Exhibit B

Monticello Nuclear Generating Plant

License Amendment Request dated September 16, 1992

EXISTING TECHNICAL SPECIFICATION PAGES WITH THE PROPOSED CHANGES ADDED

Monticello Nuclear Generating Plant Typical Power-Flow Operating Map With MELLA and Increased Core Flow

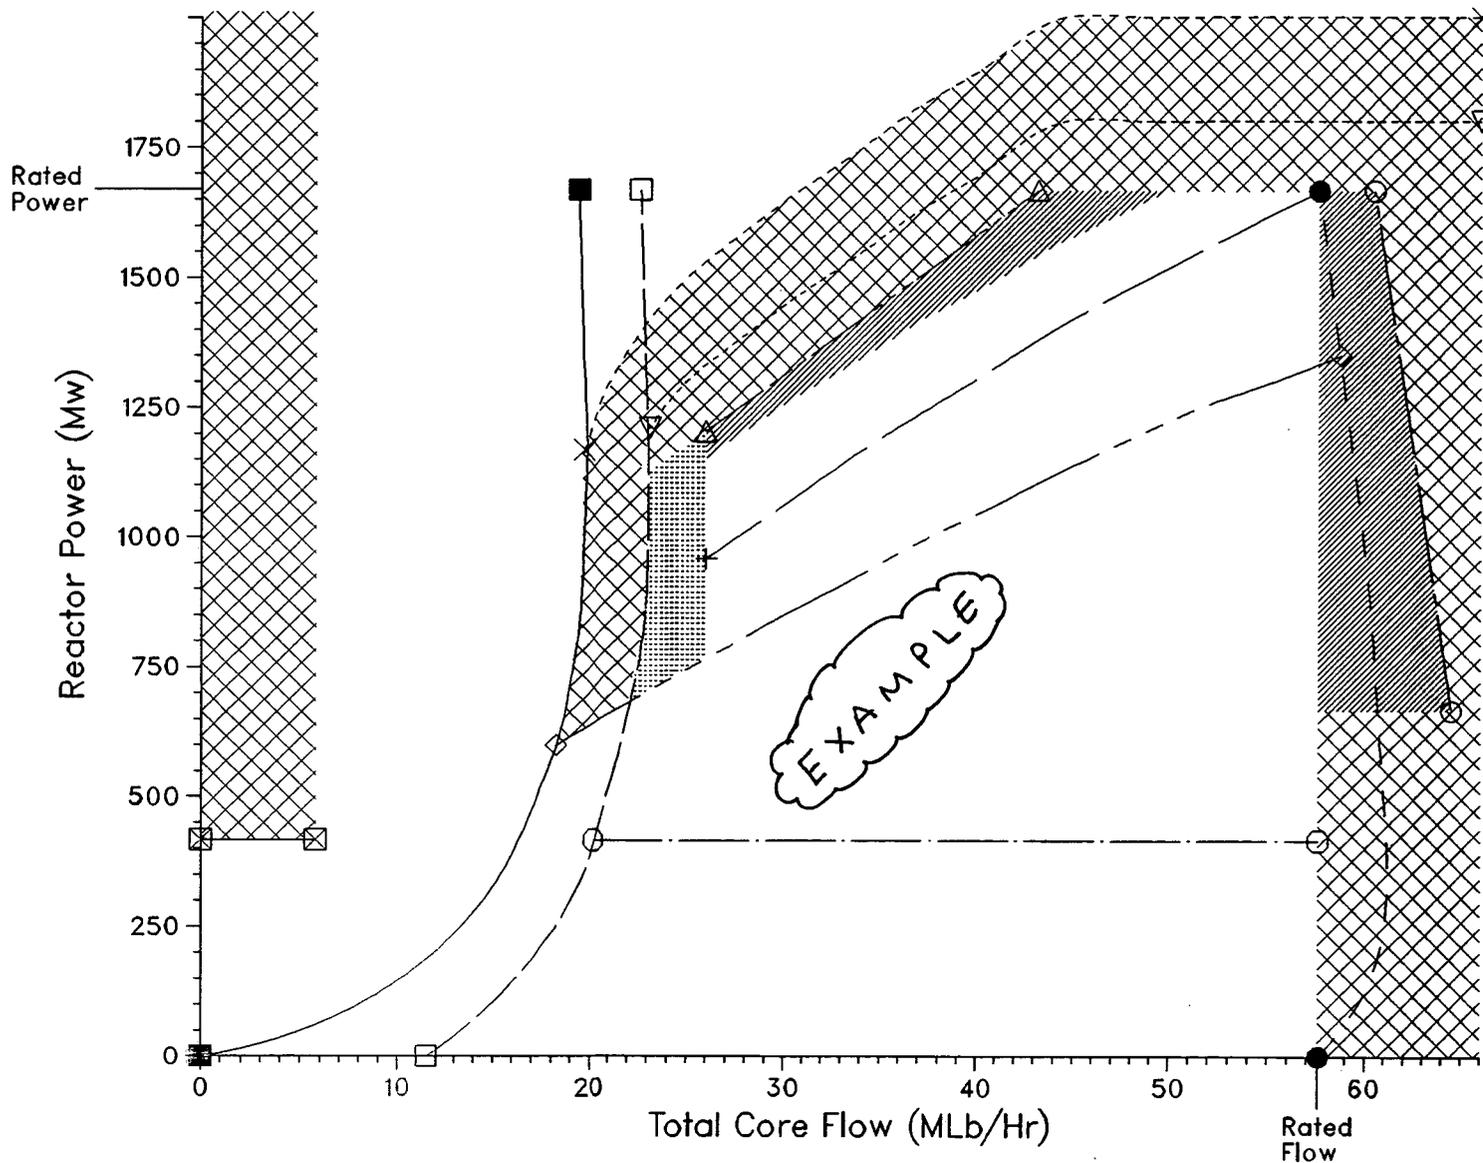
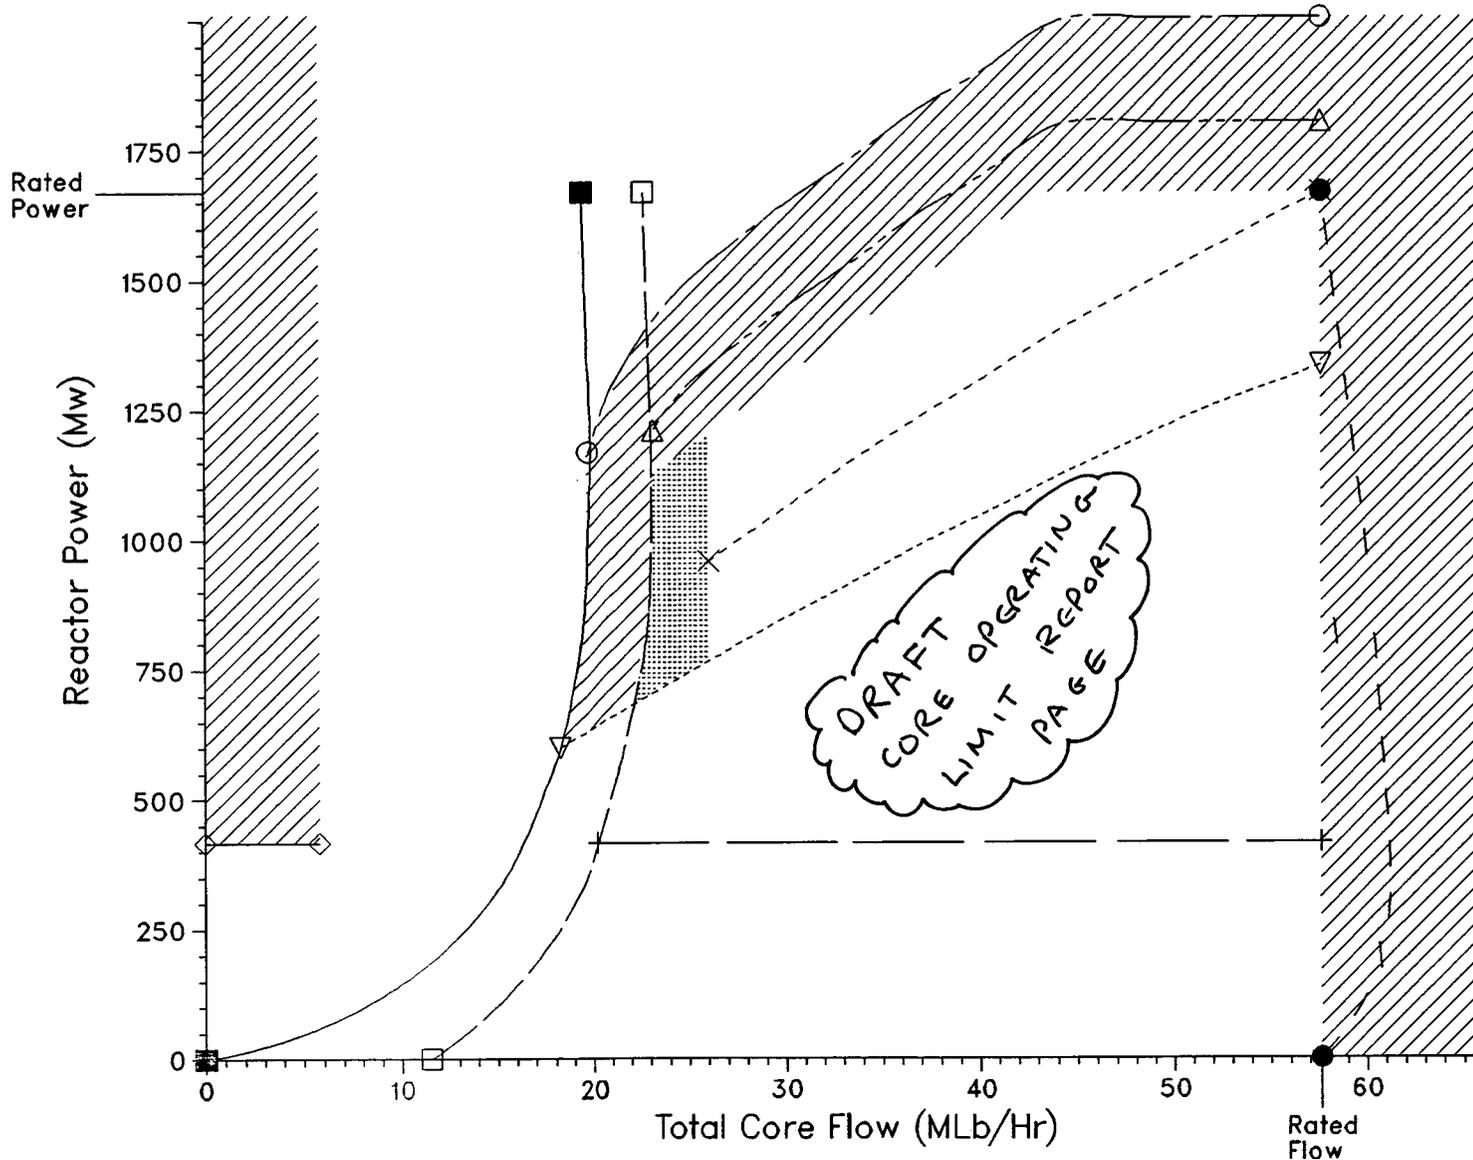
Maximum Extended Load Line Limit Analyses have been performed to allow operation at higher powers at flows below 87%. The flow referenced scram (and rod block line) have increased (higher slope and y-intercept) for two loop operation (See Core Operating Limits Report). These analyses have not changed the allowed operation for single loop operation. The supporting analyses are discussed in GE NEDC-31849P report (Reference: Letter from NSP to NRC dated September 16, 1992).

Increased Core Flow analyses have been performed to allow operating at flows above 100% for powers equal to or less than 100% (See Core Operating Limit Report). The supporting analyses are discussed in General Electric NEDC-31778P report (Reference: Letter from NSP to NRC dated September 16, 1992).

Increased Core Flow and MELLA regions shown by slanted shading
